Title-Sujet Construction - Bâtiment A		
Solicitation No. – No. de l'invitation 201801002	Amend. – Modif. No. : 9	Date 31 juillet, 2018
Client Reference No. - No. de Référence du Client 201801002		
GETS Reference No. – No de Référence du SEAG		
Solicitation Closes – L'invitation prend fin at – à 2:00 P.M. EDT on – 2 août, 2018.		
F.O.B. - F.A.B. Destination		
Address Enquiries to: - Adresser toute questions à : Jordan McKenna		
Telephone No. - No de telephone 613-843-5518	Fax: 613-825-0082	
Destination of Goods - Destinations des biens: See Herein		
Instructions : See Herein / Voir aux présentes		
Delivery Required – Livraison exigée: See Herein		
Name and Title of person authorized to sign on behalf of Vendor/Firm. Nom et titre de la personne autorisée à signer au nom du fournisseur/de l'entrepreneur

Modification N° 9

Construction – Bâtiment A
N° D'APPEL D'OFFRES : 201801002

Project Ref Number :	A000566B
Project Title :	Building A
Client :	DFS
Date :	2018/07/25

2. DRAWINGS**2.1 Drawing M100**

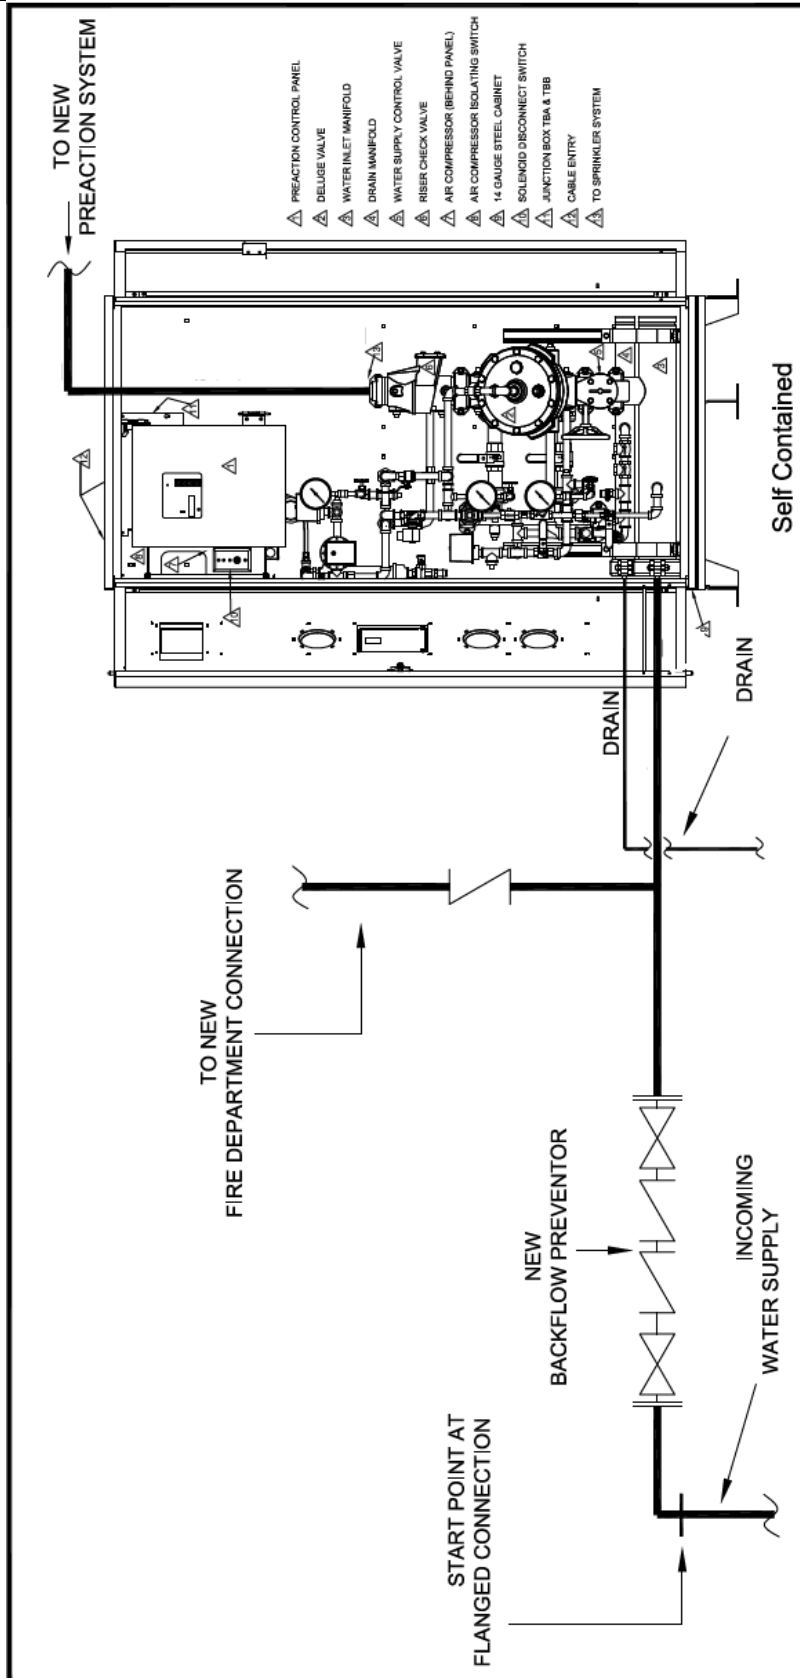
- 2.1.1 General note 2; modify "NFPA 14" to read "NFPA 13".
2.1.2 Add the pre-action schematic on the following page to the drawing.

2 FIRE ALARM SCHEMATIC DIAGRAM
NOT TO SCALE

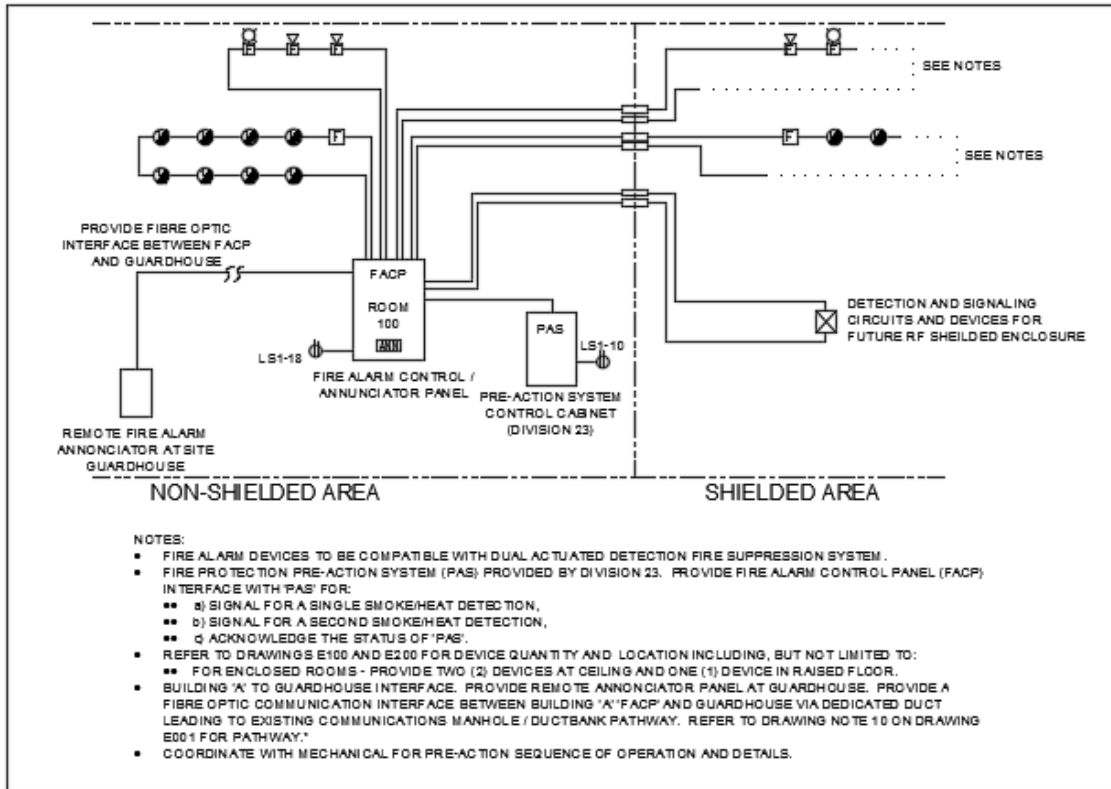
7. Locate panel 'ELS2': REPLACE text to read 'LS2'.
8. Locate detail '2', REPLACE entire detail with the following detail:
